RX-7 (13B)

SUBJECT Filter for the Vent Solenoid Valve.

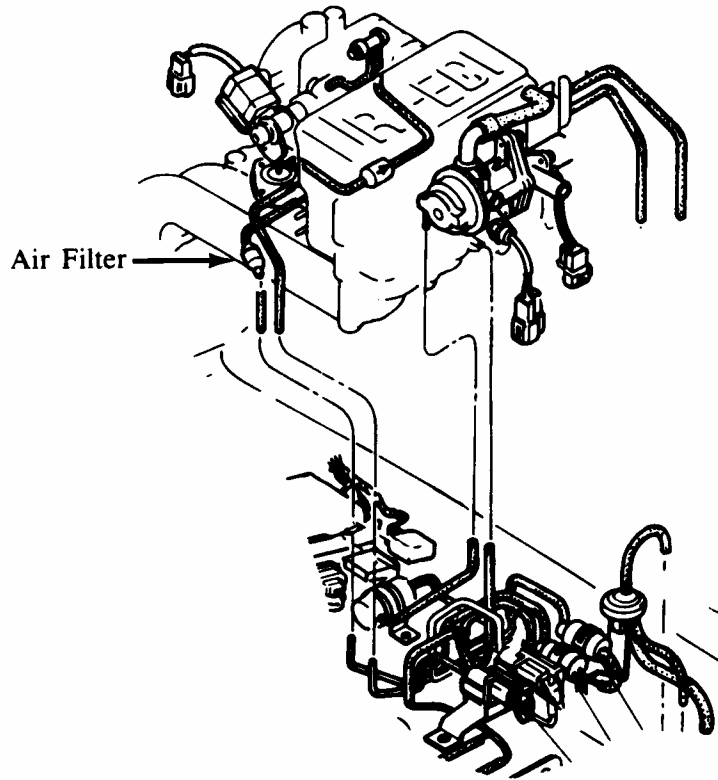
To prevent high idle speed or idle speed hunting caused by a sticking vent solenoid valve, an air filter has been installed between the dynamic chamber and vent solenoid valve since the production date of March, 1985.

The air filter kit has also been established as a service part for the vehicle produced prior to this production change. If high idle speed or idle speed hunting is caused by the malfunction of the vent solenoid valve, install the air filter and attach the vacuum diagram lable at the same time of replacing the vent solenoid valve. See Service Bulletin Category 4, 008/84 for additional information.*

Attach vacuum diagram label
